Evaluation of necessary changes to Unit 1 Technical Specifications as identified by page number.

ATTACHMENT B

Reactor Coolant System Temperature-Pressure Heatup Limitations  
Figure 3.4-2 North Anna Power Station No. 1 Reactor Coolant System Heatup  
Limitations Applicable to 5 Effective Full Power Years and Contains  
Margins of 10°F and 60 PSIG for Possible Instrument Errors

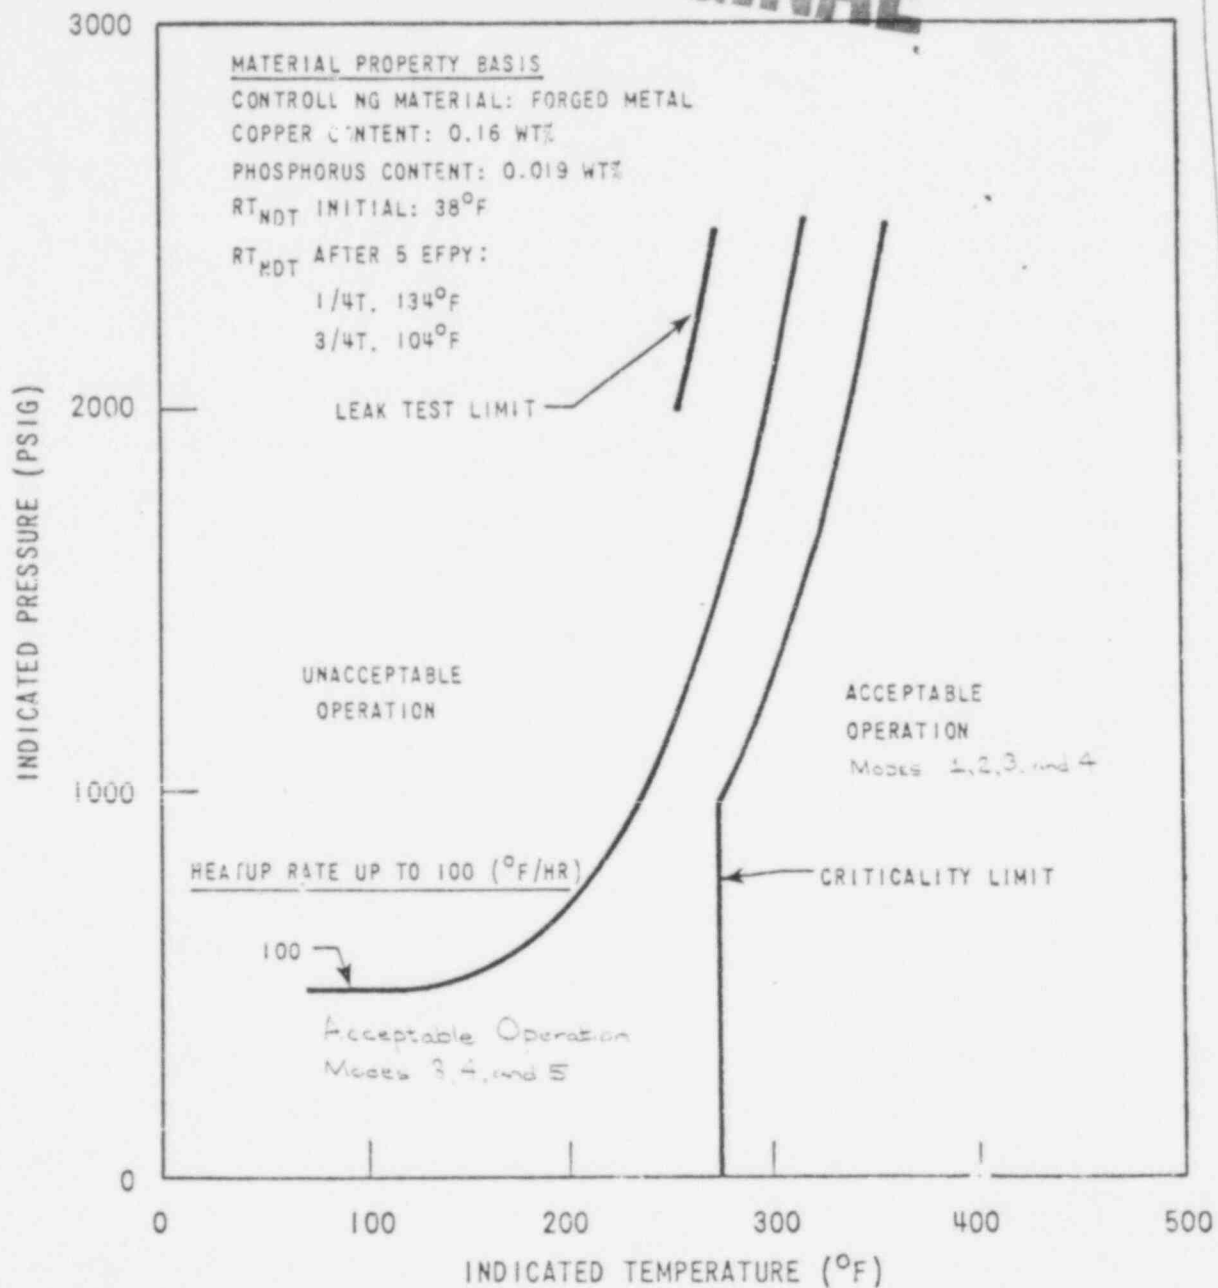
- Page 3/4 4-26\*        Update figures for heatup and cooldown curves to agree with figures  
4-27\*                previously submitted as part of the overpressure protection review.  
4-28\*                Similar to Unit 2, limits for hydrostatic testing are included.
